H. B. ROBINSON UNIT NO. 2
LICENSE DPR-23

ADDITIONAL INFORMATION - EFFECT OF AXIAL FLUX SHAPE ON LOCA

H. B. ROBINSON UNIT NO. 2
LICENSE DPR-23
ADDITIONAL INFORMATION CONCERNING LOSS-OF-COOLANT ANALYSES
JANUARY 3, 1974

FIGURE 2-1
FLOODING RATE VS. TIME
FOR CPL DECL-G

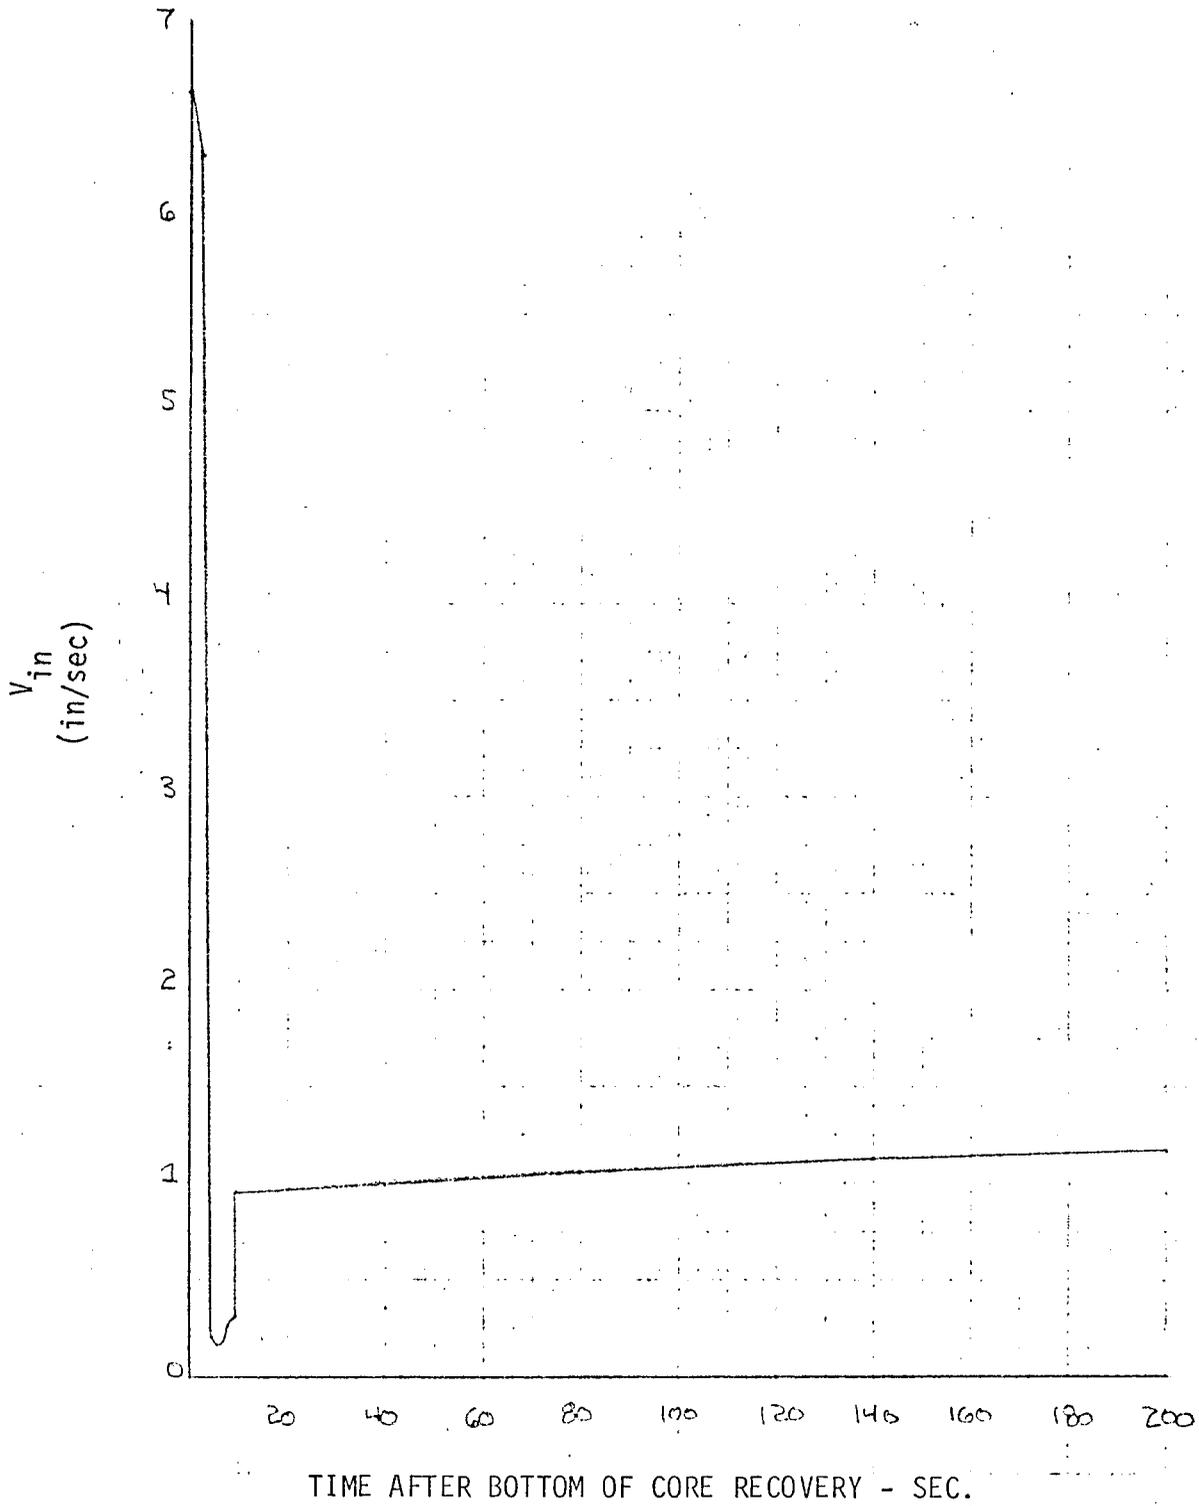
Describe how the core reflooding rate (Figure 1) is modified for use as input to the computation of FLECHT heat transfer coefficients; include the actual values used in each case.

The core flooding rate shown in Figure 1 of the previous submittal is not actually modified for use as input to the computation of FLECHT heat transfer coefficients for all of the power shapes analyzed. This flooding rate is calculated using the carryover fraction specified in the Interim Acceptance Criteria for W reactors. This carryover fraction is conservatively high and tends to yield lower core flooding rates.

The flooding rate presented in Figure 1 is used directly in the calculation of the heat transfer coefficient. However, in order to apply the FLECHT correlation to a varying flooding rate, the history of the reflood transient must be considered. This is accomplished by using a pseudo time in the FLECHT correlation which is calculated as the integral of the reflood water that entered the core up to some time (t) divided by the actual flooding rate at time (t). That pseudo time is used as the time argument in the FLECHT correlation.

Figure 4-1. Schematic Diagram of Quench Front Curves of a FLECHT Test and a Skewed Power Case

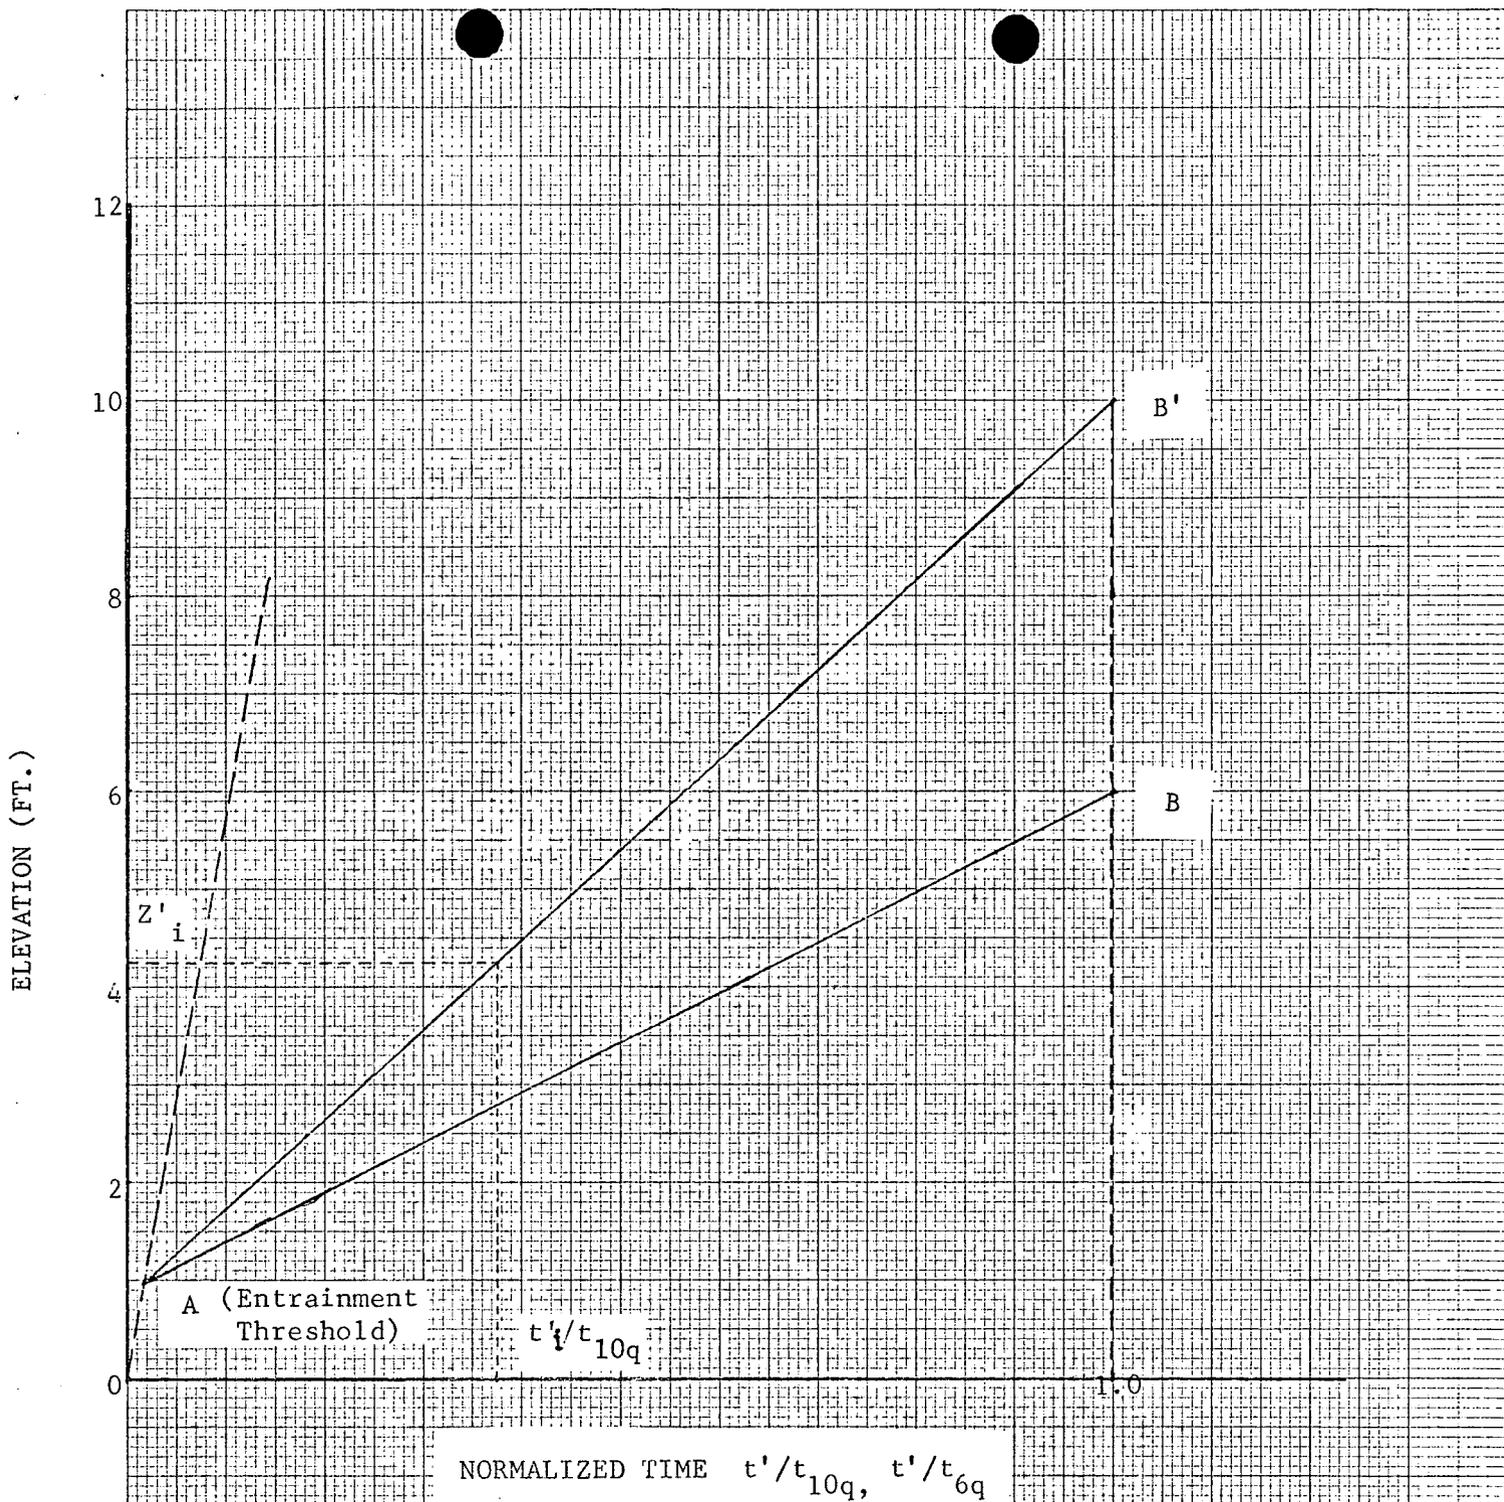
The FLECHT correlation is keyed to a symmetric flux shape with a flux peak at 6 ft., the initial cladding temperature at 6 ft., the heat generation rate at the 6 ft. level, the time to quench the 6 ft. elevation, and the integral of heat release up to the point in question. All of these factors vary when the axial shape is non-symmetric. Describe, in detail, the mathematical treatment that is applied to FLECHT data to generate heat transfer coefficients at any elevation.

It appears in the response to Question 5 that the heat transfer coefficients at the upper elevations were taken directly from symmetric shape data. In order to clarify this matter, provide the input data, and suitable justification, for each of the three curves on Figure 2.

The method consists of first constructing a quench front curve for the skewed power shape and a corresponding cosine FLECHT power shape in which the total integrated power up to the six-foot elevation is the same as the integrated power up to the peak location for the skewed shape. This quench curve is a plot of quench front elevation versus time. The skewed bundle peak location quench time can then be calculated using the FLECHT quench correlation with the appropriate power peak calculated to preserve the total skewed profile power up to the peak. Comparisons made using FLECHT data for cosine power shapes of varying peak power levels verify that, for elevations below the peak power elevation, quench time is a function of integrated power beneath the quench front and not the quench front elevation (within the range of FLECHT conditions). It follows that the calculated quench time for the equivalent FLECHT cosine power shape is the same quench time for the skewed power shape. This fixes one point on the quench curve for the skewed power shape. The second point of the quench curve is the point where "cold filling"

In order to calculate the heat transfer at the peak elevation for the skewed power shape, it is necessary to match up the skewed power quench curve and compare locations and times to the 6-foot FLECHT quench curve. Since the two normalized quench times are equal, the 6-foot FLECHT power peak is adjusted to preserve the same total power below 6' and below the peak location of the skewed power profile. That is
